Amendment No. 0001
08 April 2002

SUBJECT: Amendment No. 0001 to Specifications and Drawings for Construction of
Rehabilitation of Federal Streambank Stabilization Project 2002,
Missouri River, Mile 800 to 753, Nebraska and South Dakota.
Solicitation No. DACW45 02 B 0005.

MR 28 E 005 (partial)

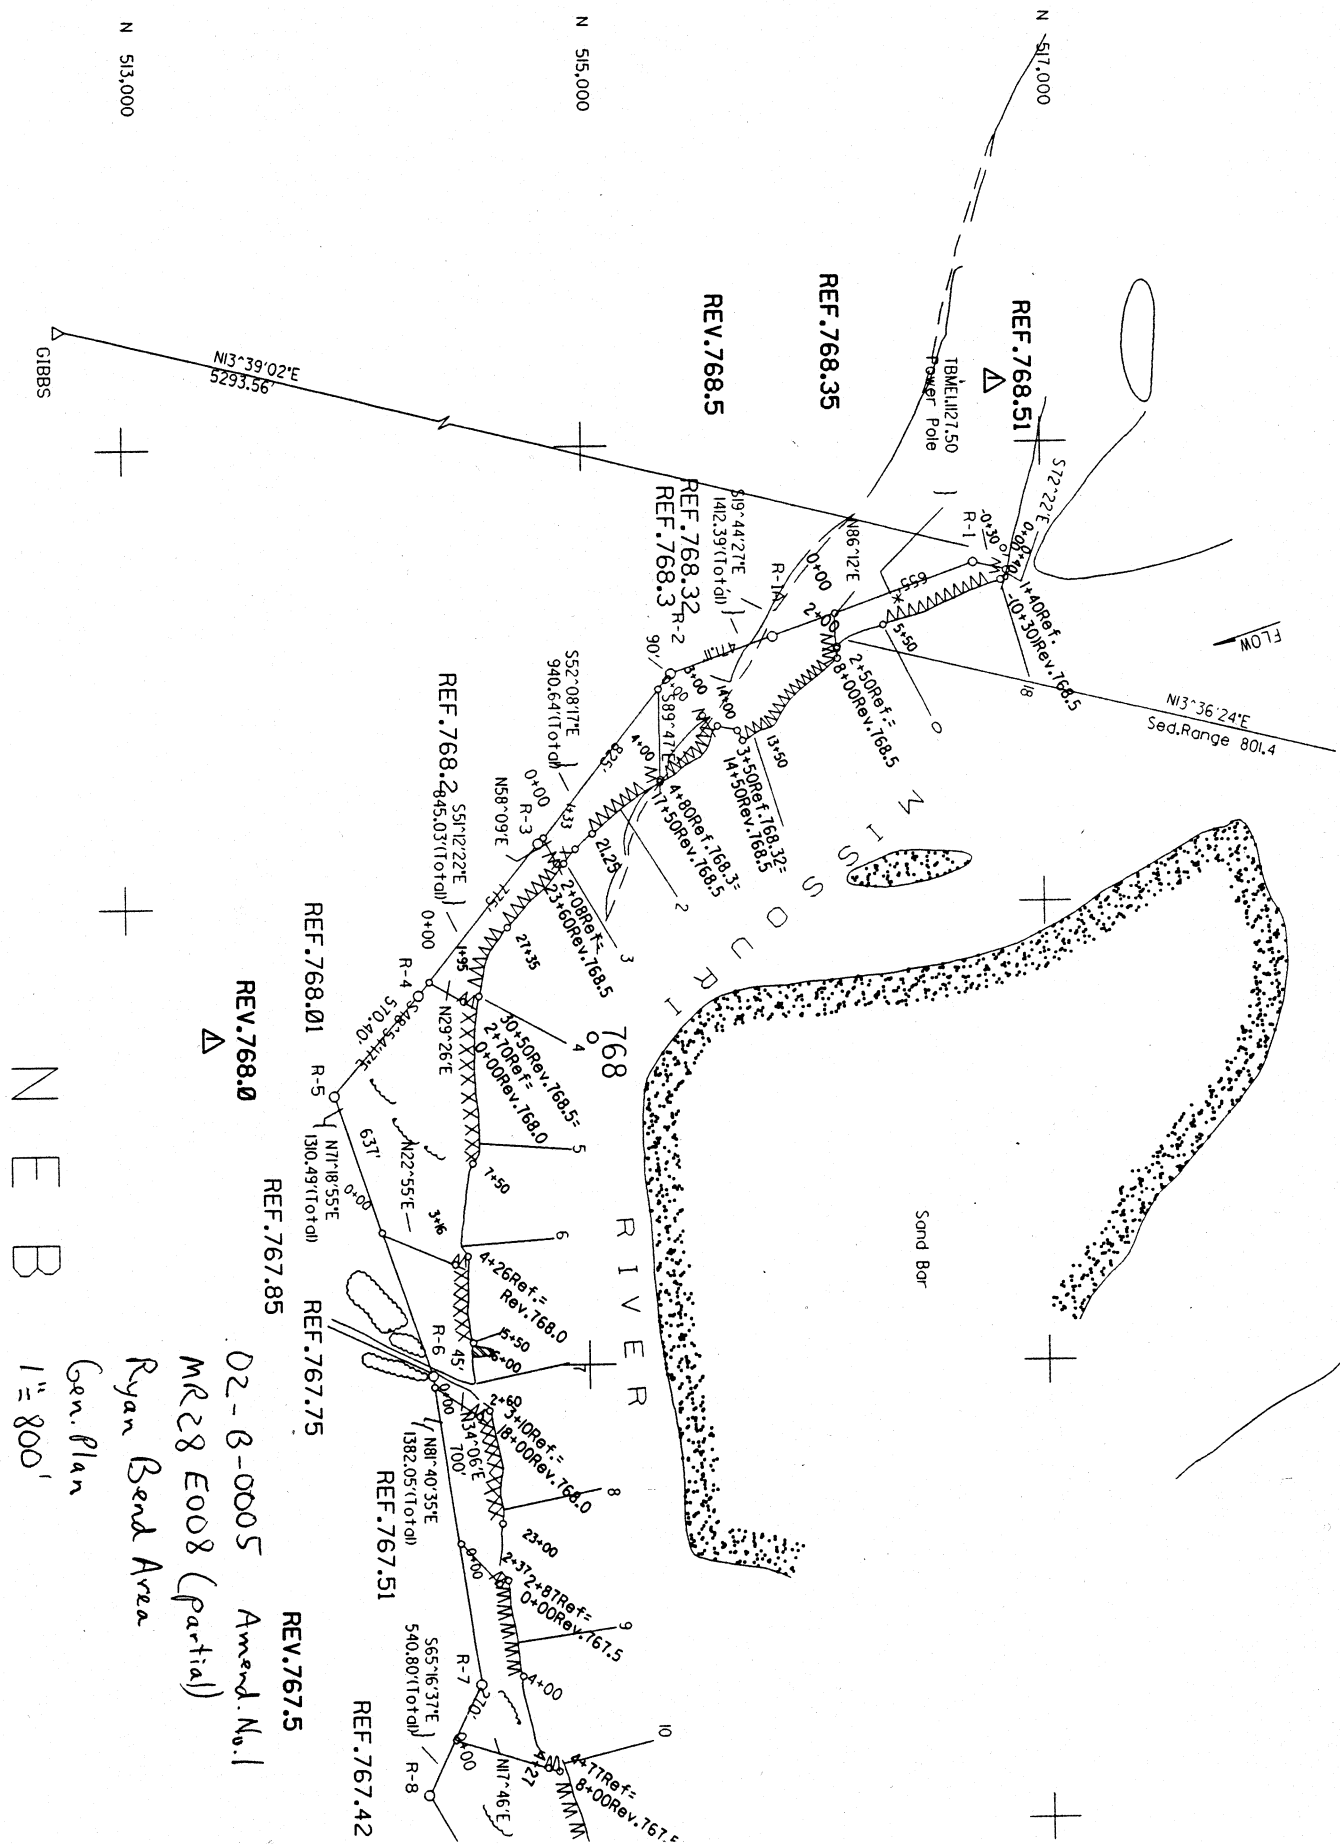
(2) Sheet MR28E005, General Plan Sheet 1, revise as shown on the attached sheet, it now identifies REF 784.36 and REV 783.97
